SUBJECT: Responds to NRC 900919 request for addl info re util rept,
NTH-TR-01, "RETRAN Model Clarification - Decrease in Heat
Removal by Secondary Sys."

L-91-108

Re: Response to Request for Additional Information
Related to Topical Report NTH-TR-01, RETRAN Model
Qualification - St. Lucie Plant Unit Nos. 1 and 2
and Turkey Point Plant Unit Nos. 3 and 4 (TAC Nos. 75082,
75083, 75084 and 75085)

FIGURE 1. CORE POWER

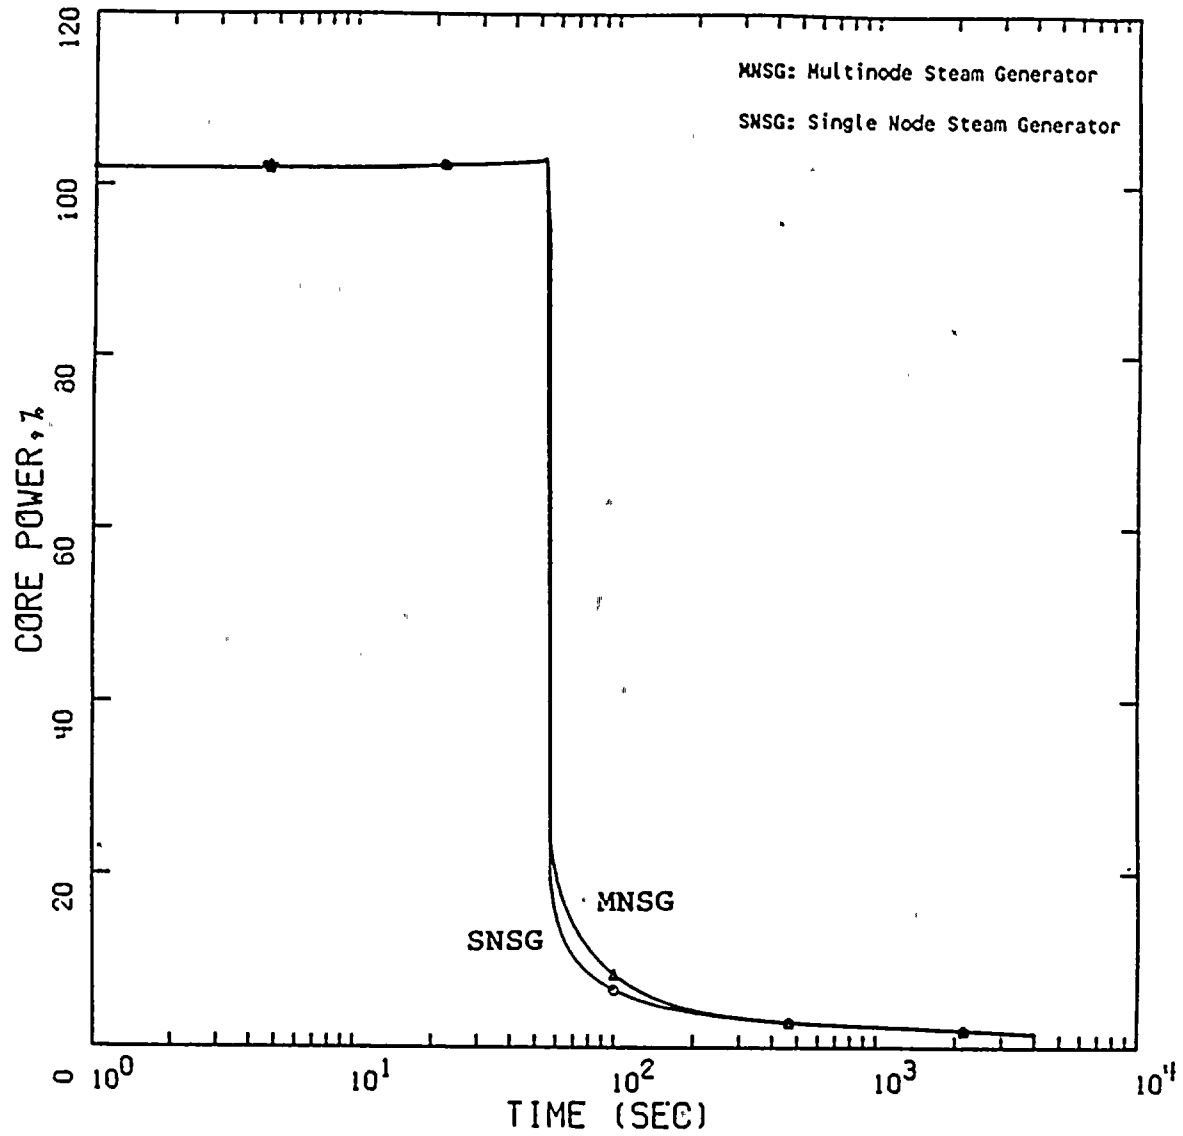
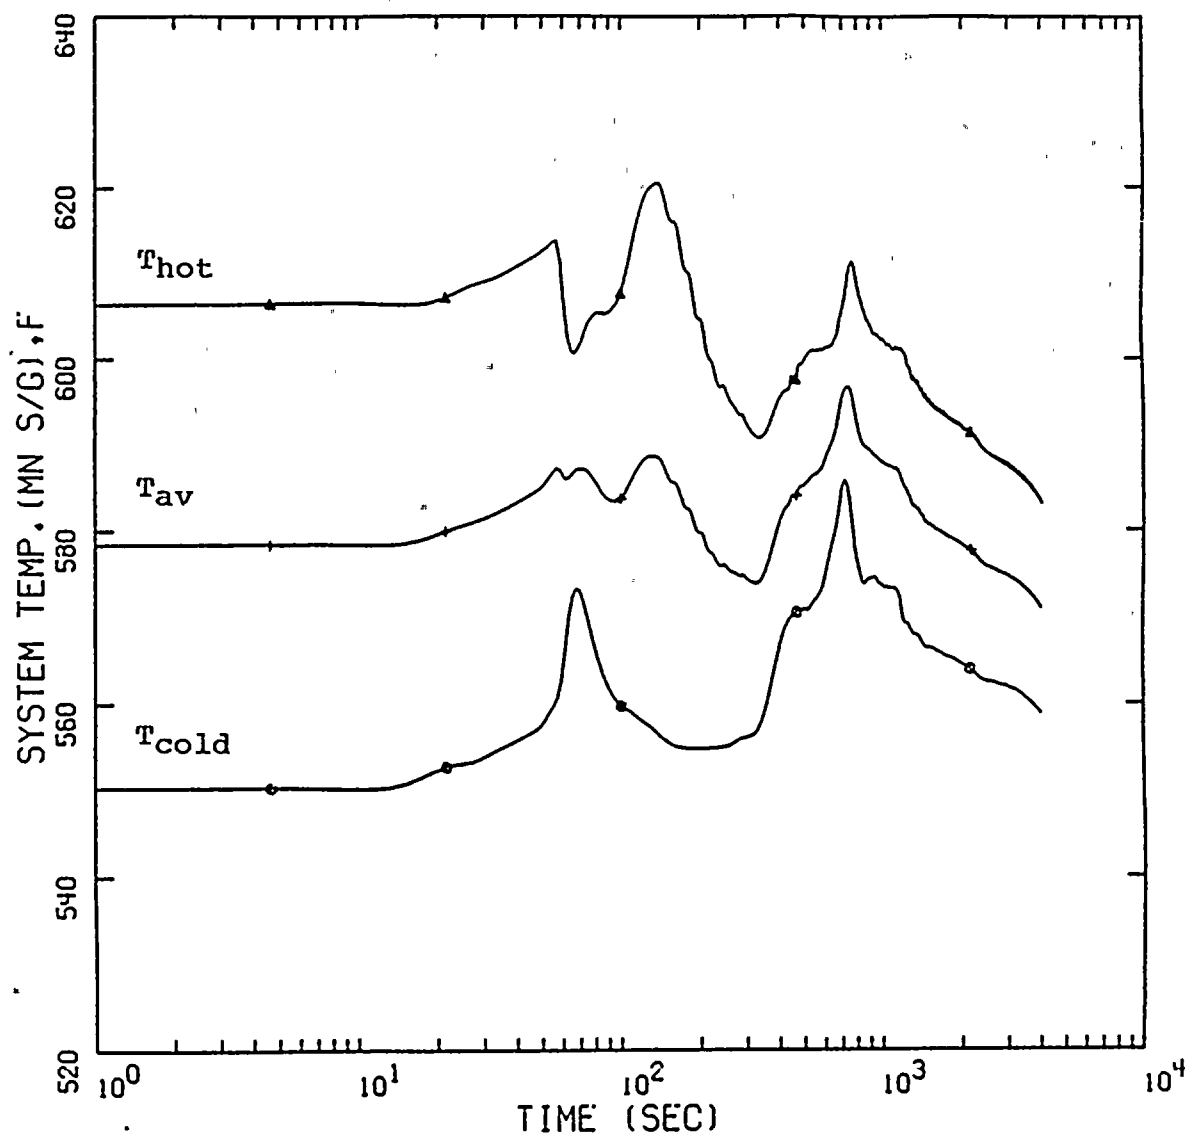
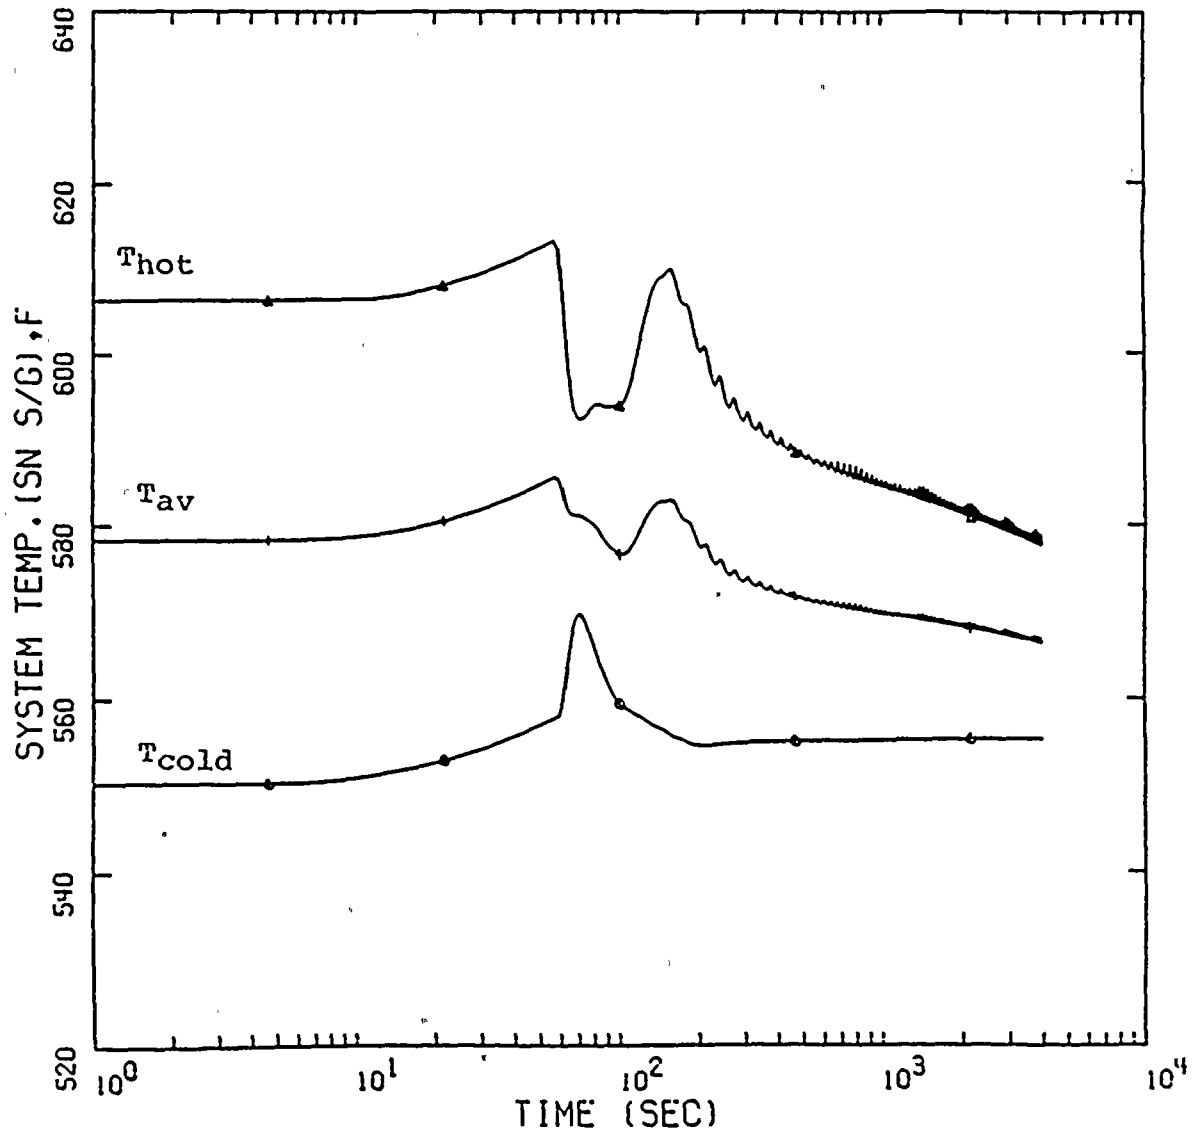
QUESTION: Demonstrate, by steam generator nodalization parametric studies, that the chosen nodalization for each vendor's plant produces conservative results compared to other nodalizations.

The attached plots compare the RETRAN results of the Turkey Point Loss of AC Power Transient with single-node and multinode steam generator models. The multinode steam generator analysis is the one reported in the Reference Submittal (Section 4.2.3.6). The single-node analysis is based on a model in which the initial steam generator inventory has been adjusted to match the time of the low level trip in the multinode analysis. The time of low level trip in the single-node analysis had to be approximated with a vendor provided trip-equivalent steam generator inventory.

FIGURE 1. PRESSURIZER PRESSURE
MSSV SENSITIVITY

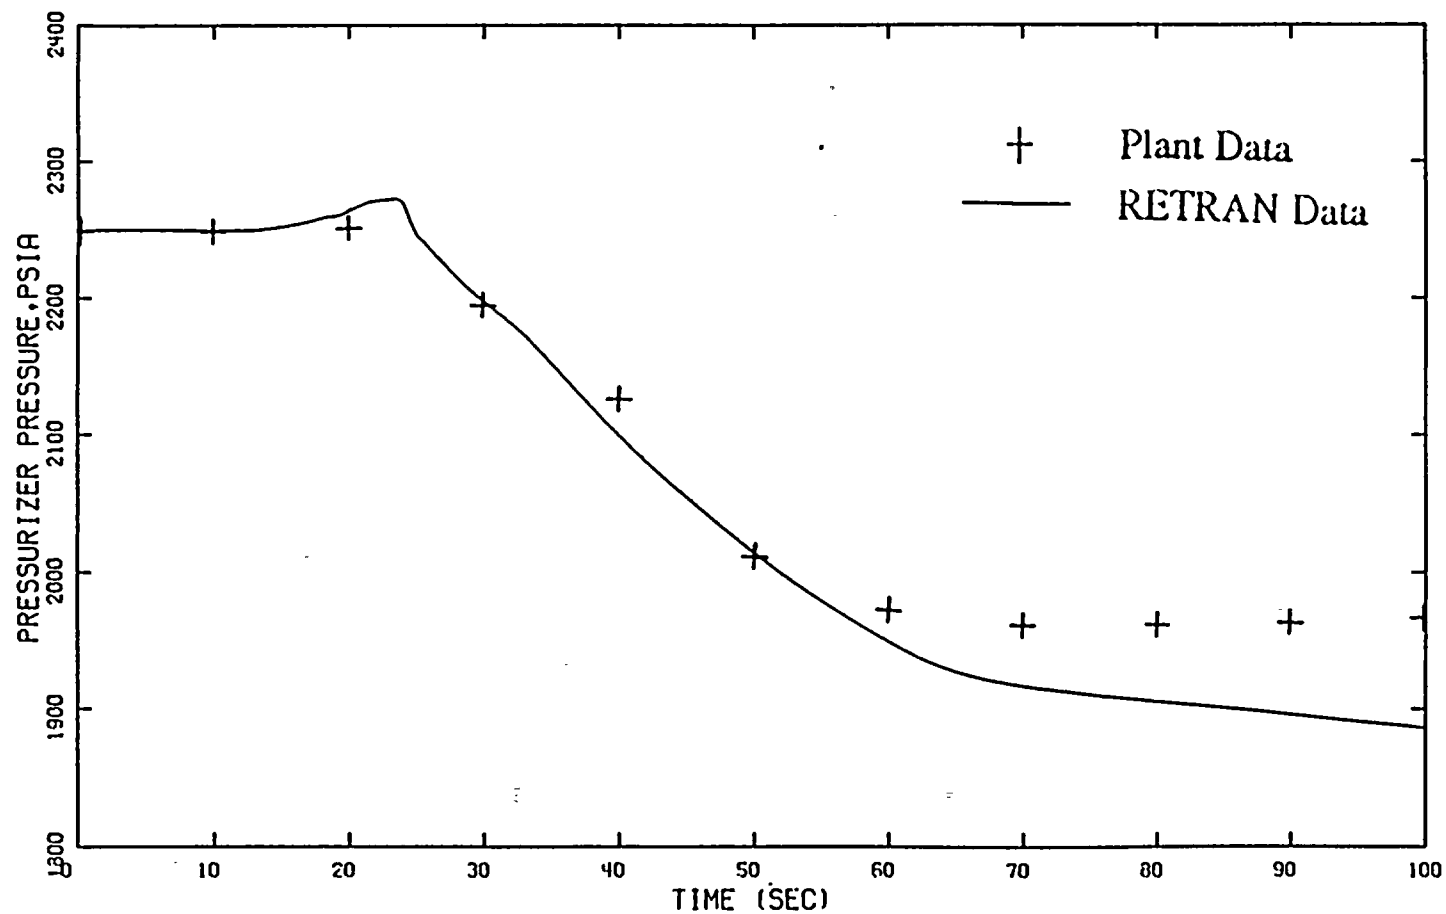
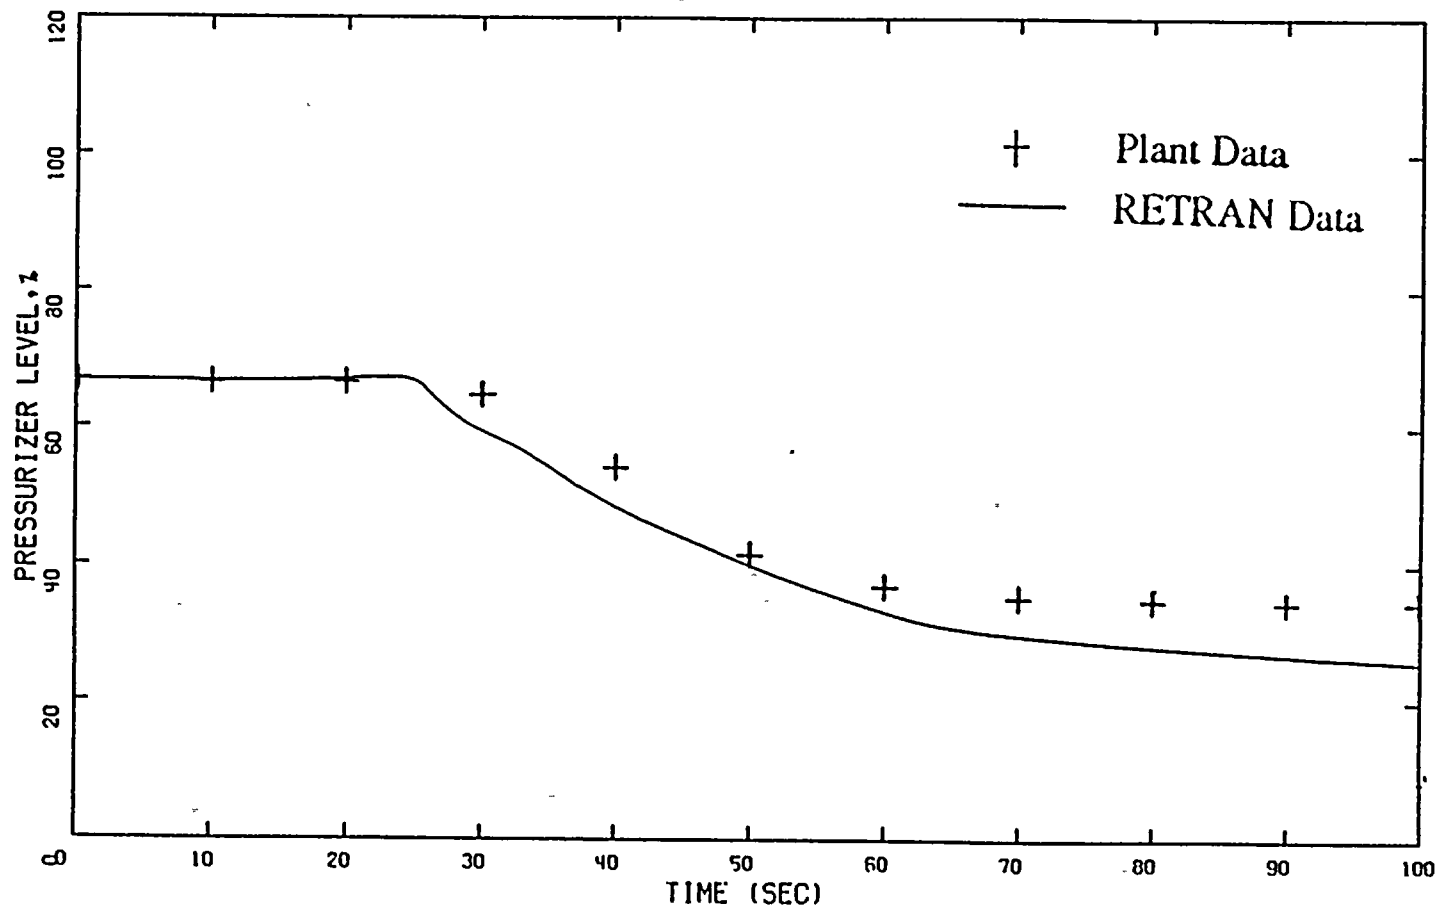
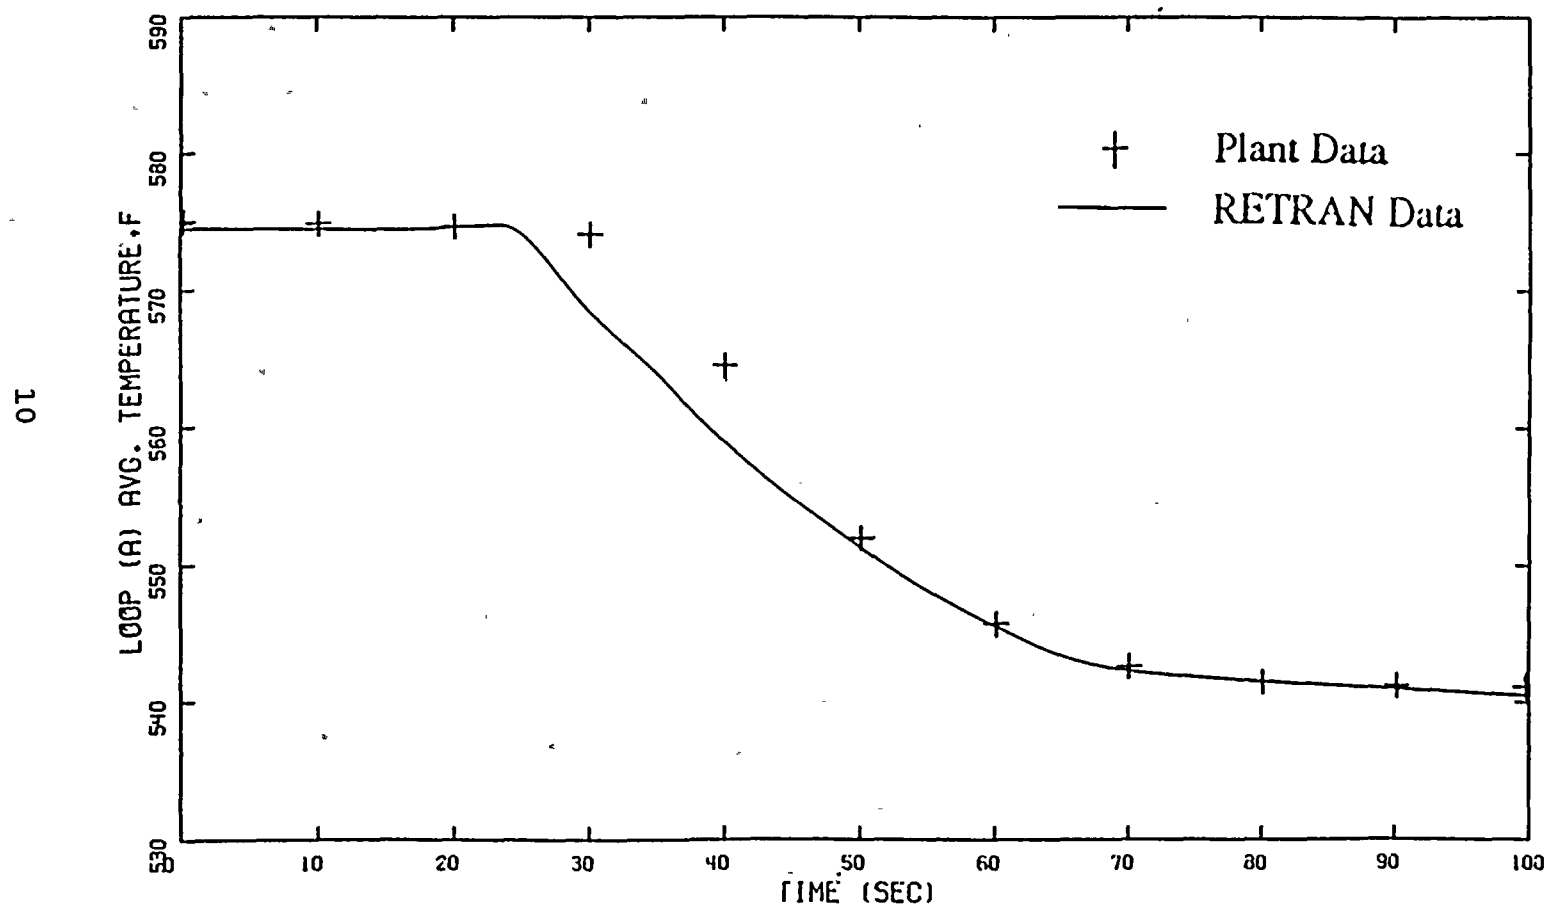
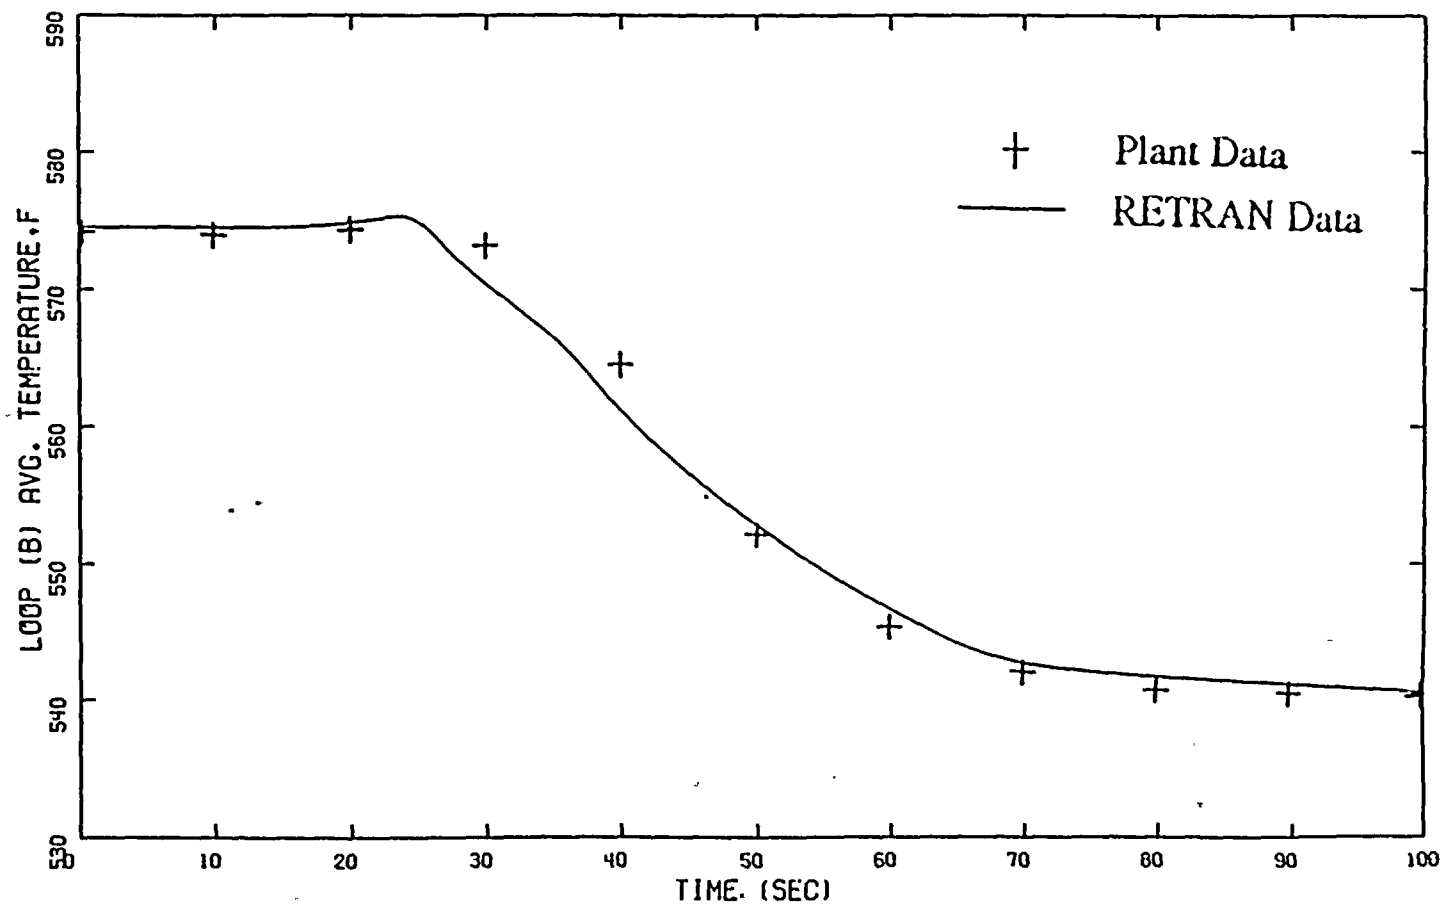
QUESTION: Explain how the MSSV component input was determined. Provide any physical basis for the assumptions made in the sensitivity study with respect to the flowrate and the number of valves operating. Did FPL change nodalization as a result of observing that separately modeling the MSSV's lead to better comparison with measured data? Provide comparisons of other computed parameters on the primary side with measured data after the change in MSSV modeling. Explain the differences between predicted and measured steam generator pressure and level trends after 40 seconds.

Figures 1 through 4 show the requested comparisons between plant data and the RETRAN predictions for primary side parameters.
